Agenda Item # 2 - HOLDOVER

SUB-003240-2025 & ZON-UDC-003426-2025

Star Light at Cottage Hill Subdivision

APPLICATION NUMBER	2	DATE	September 18, 2025
APPLICANT	Star Light at Cottage Hill Subdivision		
REQUEST	Subdivision, Rezoning from R-1 to R-3

SITE PLAN

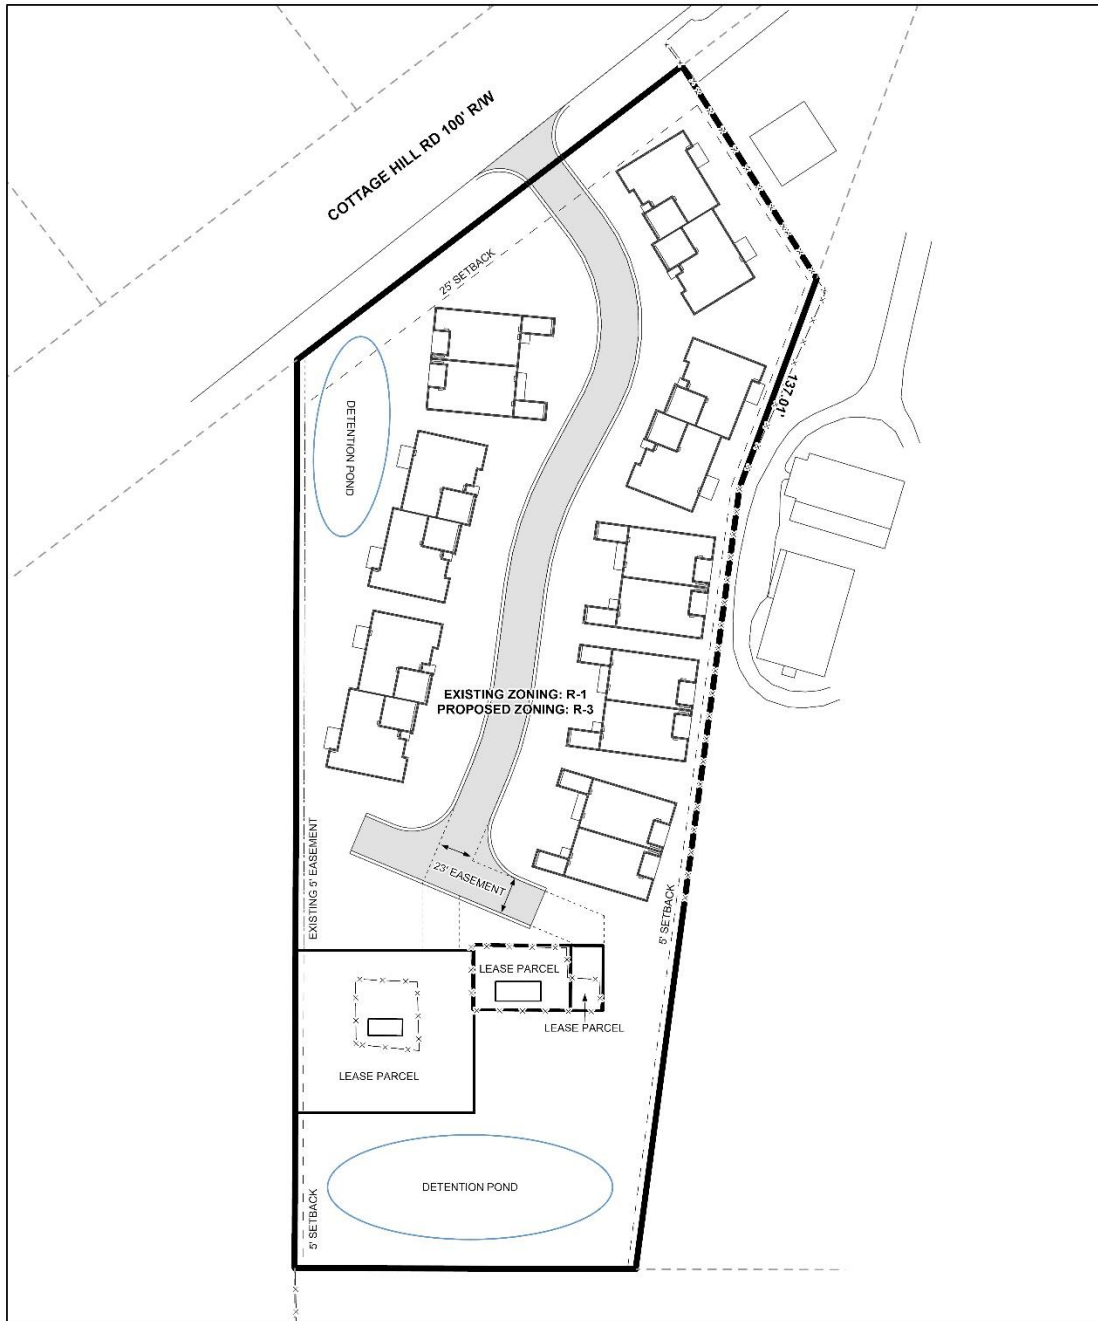
The preliminary plat illustrates a single proposed lot, labeled Lot 1, and two (2) lease parcels, each of which exceeds 3,000 square feet in area and are developed with a telecommunications tower and associated equipment. Under current regulations, any parcel 3,000 square feet or more must be established as a legal lot of record. Although the lease parcels existed in their current configuration prior to annexation, the concurrent Rezoning application reflects an intent to redevelop the property, thereby triggering the requirement for full compliance with current regulations, including the Subdivision Regulations.

As the Subdivision request is for two (2) legal lots, the plat must be revised to clearly depict the configuration of both proposed lots, as staff cannot infer the intent of their design from the application materials provided.

The site fronts Cottage Hill Road, classified as a Minor Arterial Street, which requires a 100-foot-wide right-of-way at this location. Although the preliminary plat reflects a varying right-of-way width, internal mapping data and parcel records suggest that sufficient right-of-way exists. Therefore, if approved, the plat must be revised to clearly depict either the minimum existing right-of-way width or a dedicated 100-foot-wide right-of-way, whichever is greater.

A 23-foot-wide access and utilities easement is illustrated on the preliminary plat, providing access to both lease areas via a driveway through the proposed development. Given that traffic generated by telecommunications towers is generally limited to periodic maintenance, this configuration may be sufficient. Nonetheless, a waiver of Section 6.C.4. will be required for approval of the subdivision as proposed.

No information is provided for the second proposed lot, preventing staff from verifying whether it meets the minimum size requirements of the UDC. The revised plat must, therefore, include the area of the second lot in both square feet and acres.

Additionally, two existing easements are shown: a 30-foot-wide access easement along the west property line and a 20-foot-wide access easement near the east property line. Both easements are proposed to be vacated in favor of the newly illustrated access and utilities easements.

1. Revise the plat to clearly depict the configuration of both proposed lots;
2. Revise the plat to clearly depict either the minimum existing right-of-way width or a dedicated 100-foot-wide right-of-way, which is greater, along Cottage Hill Road;
3. Revise the plat to include the area of the second lot in both square feet and acres;
4. If the applicant instead intends to create three (3) legal lots to correspond with the boundaries of the lease parcels, the applicant must submit a revised plat, new mailing labels, and additional fees for the third lot.
